Addendum No. 2

PROJECT: AJ's Bar and Grill Glenwood MN 56334

ADDENDUM NO.1 DATE: October 22, 2026

PROJECT: AJ's Bar and Grill

A101 Floor Plan:

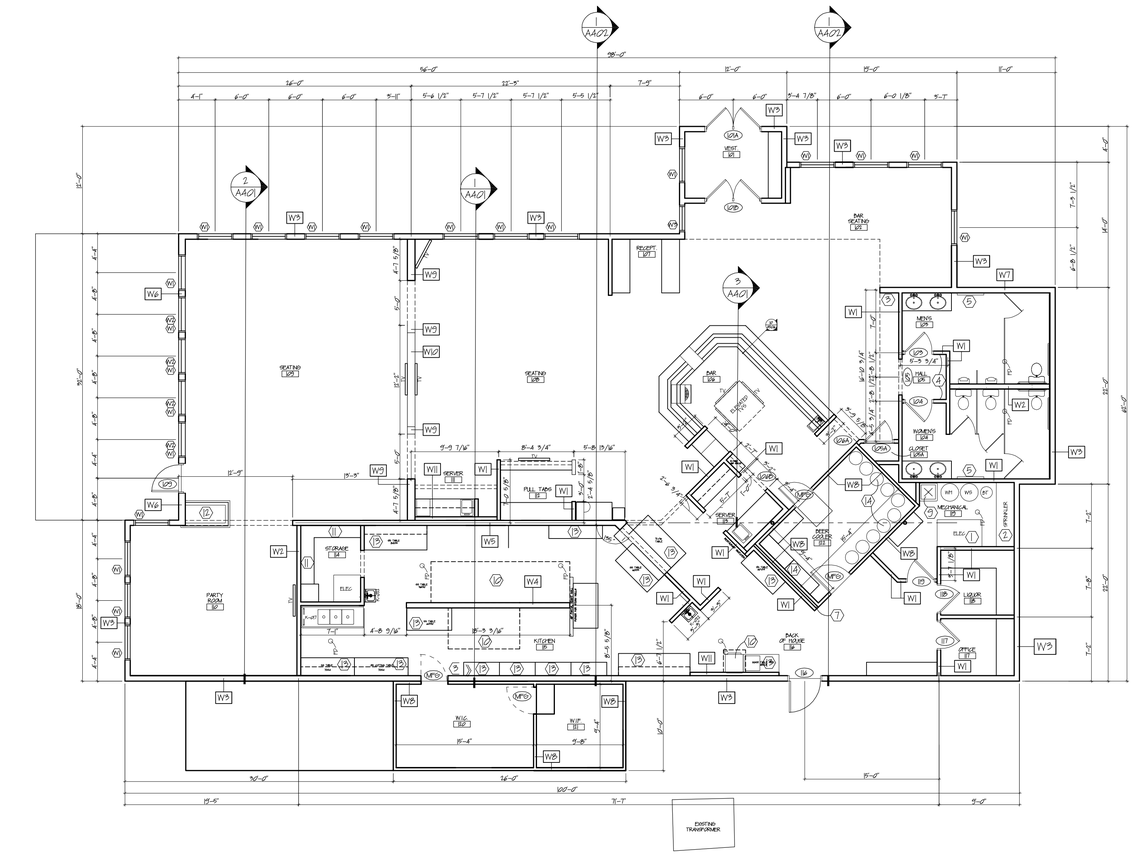
1. The door type and frame type were reversed; this has been changed on the attached plan.

1 / A102 REFLECTED CEILING PLAN

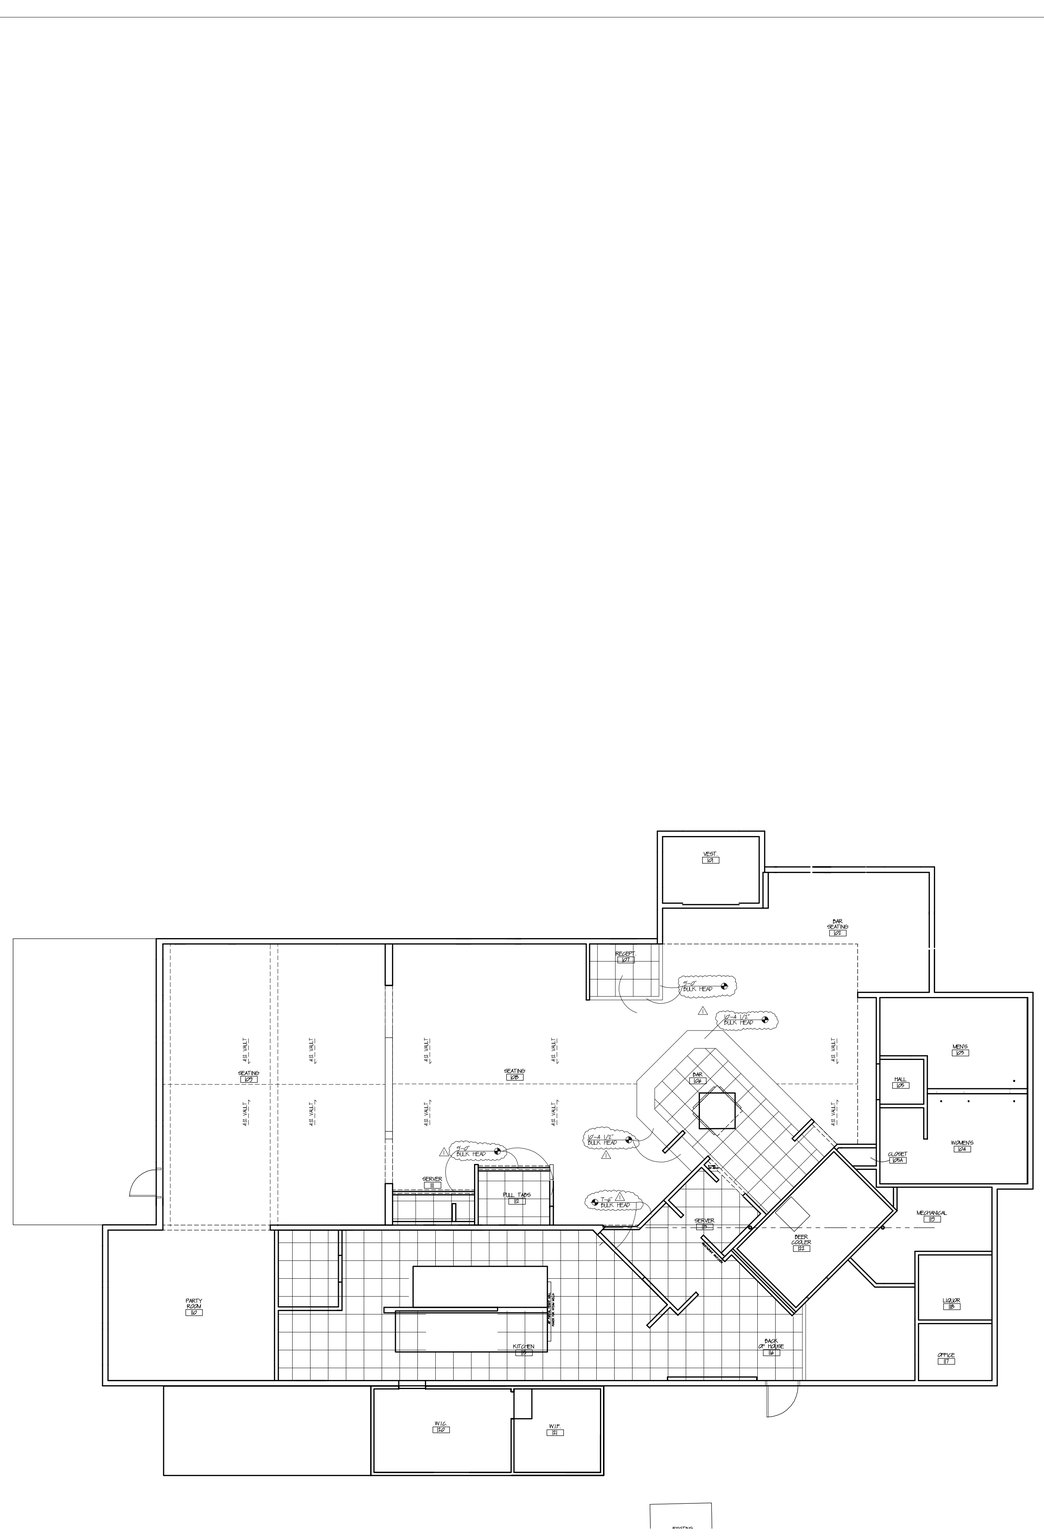
1. Revised the finish schedule.
    i. Room 106 Bar: FLR-1 and FLR-1 base required.
    ii. Room 113 Server: FLR-1 and FLR-1 base required.
    iii. Room 115 Kitchen: Base shall be FLR-1 not VB
    iv. Room 118 Liquor: FLR-1 and FLR-1 base required. FRP wall finish in lieu of gypsum.
    v. Room 120 Walk-In Cooler: FLR-1 required in lieu of sealed concrete.
    vi. Room 121 Walk-In Freezer: FLR-1 and FLR-1 base required.
    vii. Room 122 Beer Cooler: FLR-1 and FLR-1 base required.
2. Added bulk head tags for heights of bulk heads.

4 / A506 SERVER ELEVATION

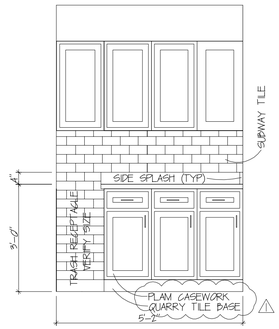
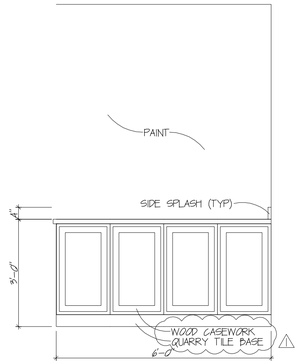
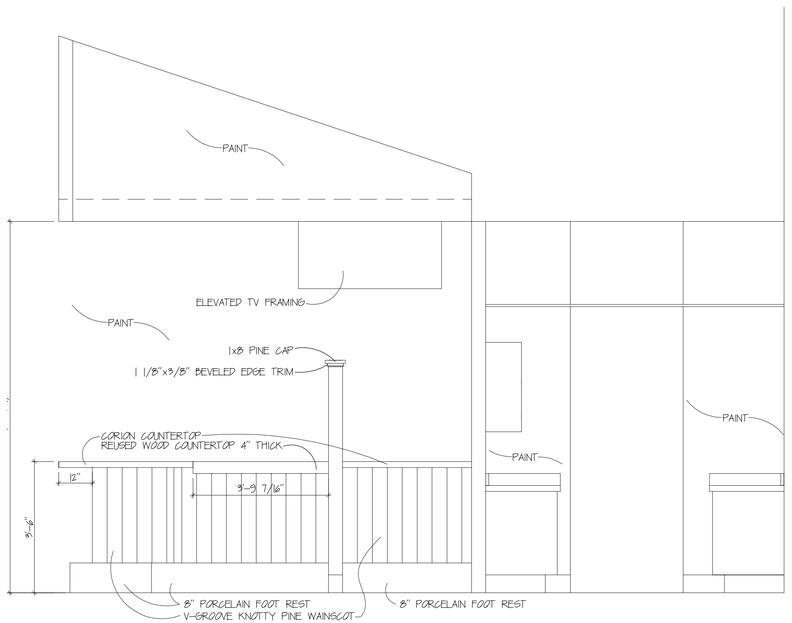
1. Revised the finish schedule.
    i. Server 111 shall have PLAM casework in lieu of wood casework
    ii. Server 113 shall have PLAM casework in lieu of wood casework

1 M101 MAIN FLOOR PLAN - PLUMBING

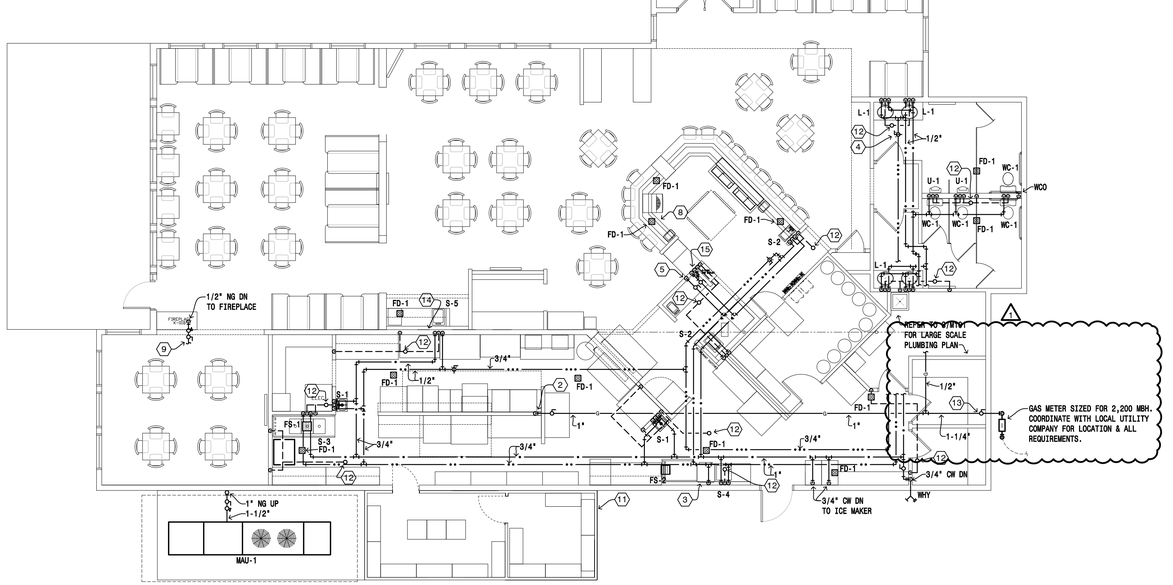
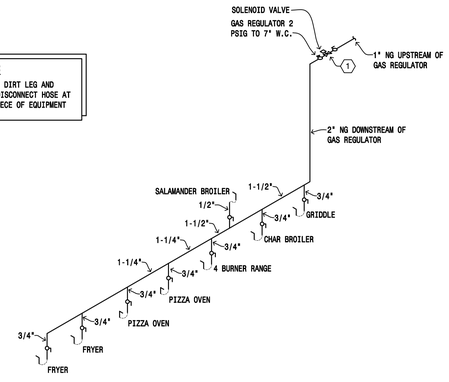
1. Gas piping to the water heater has been added to this sheet.

1. **M101 – Main Floor Plan - Plumbing**
   a. See attached plan for gas routing to water heater.

14. ROUTE 1/2" COLD WATER TO POP GUN.
15. BRANCH 1/2" COLD WATER LINES TO EACH POP GUN AT THIS LOCATION.
14. NATURAL GAS DOWN TO WATER HEATER. SIZE PER MANUFACTURER'S RECOMMENDATIONS.
